SUNDRY NOTICES AND REPORTS ON WELLS

Florance I 38B

30-045-31842

☐ Other Exception to

Client : bp
Well : Surface Job (80F)
String : 15.8 ppg G + 3% S001
District :
Country : USA

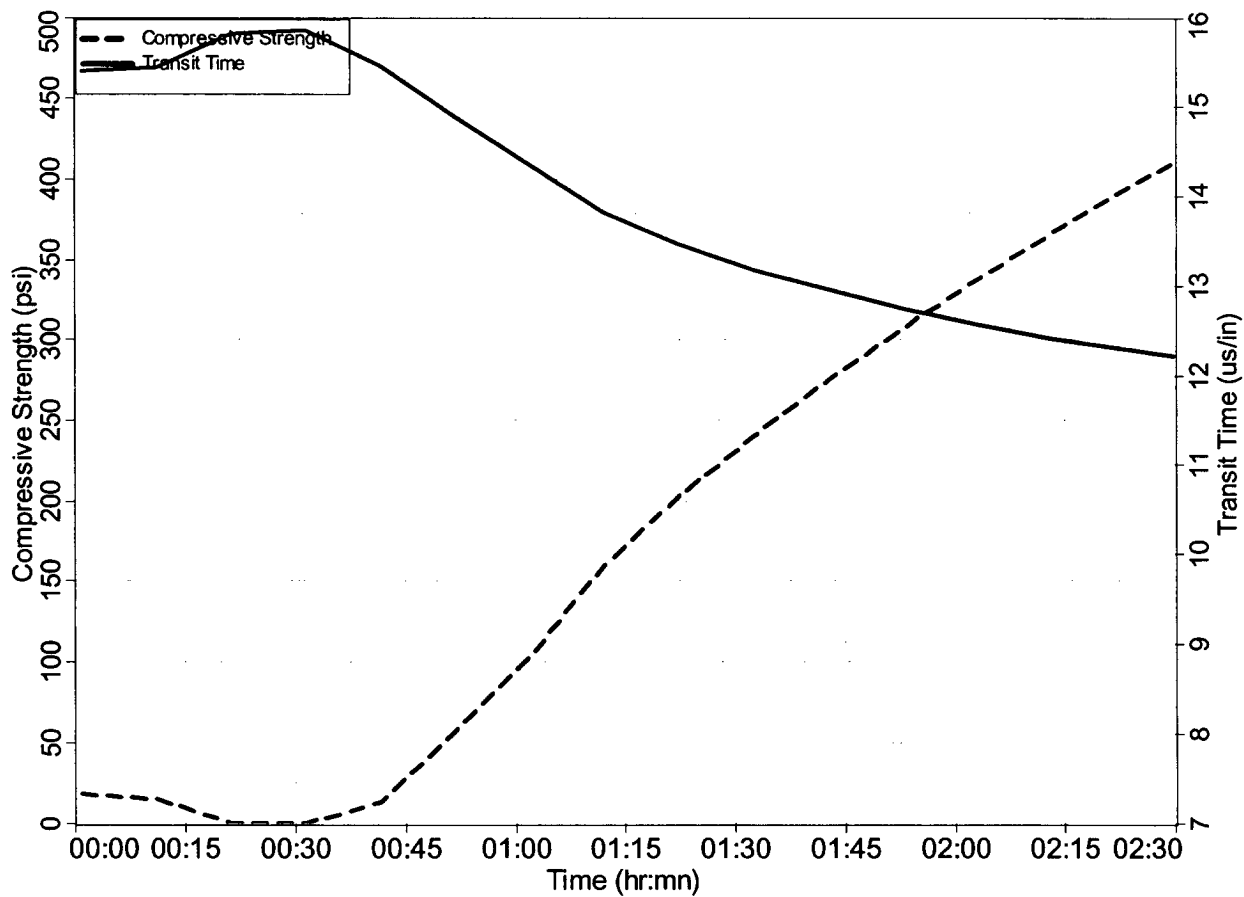
BP is currently using 3% CaCl₂ in our slurry and achieves 300 psi compressive strength after 1 hr 50 min and 500 psi after 3 hrs 8 min. We, therefore, request approval to initiate blowout preventer (BOP) nipple up operations after a 2 hour wait on cement time in lieu of the 6 hour time frame required by rule to achieve 300 psi compressive strength with Class B cement slurry at 80 deg F.

3% CaCl₂ will be used, NOT 2% as originally approved.

Comply with nmocd

NMOCD Rule 1076
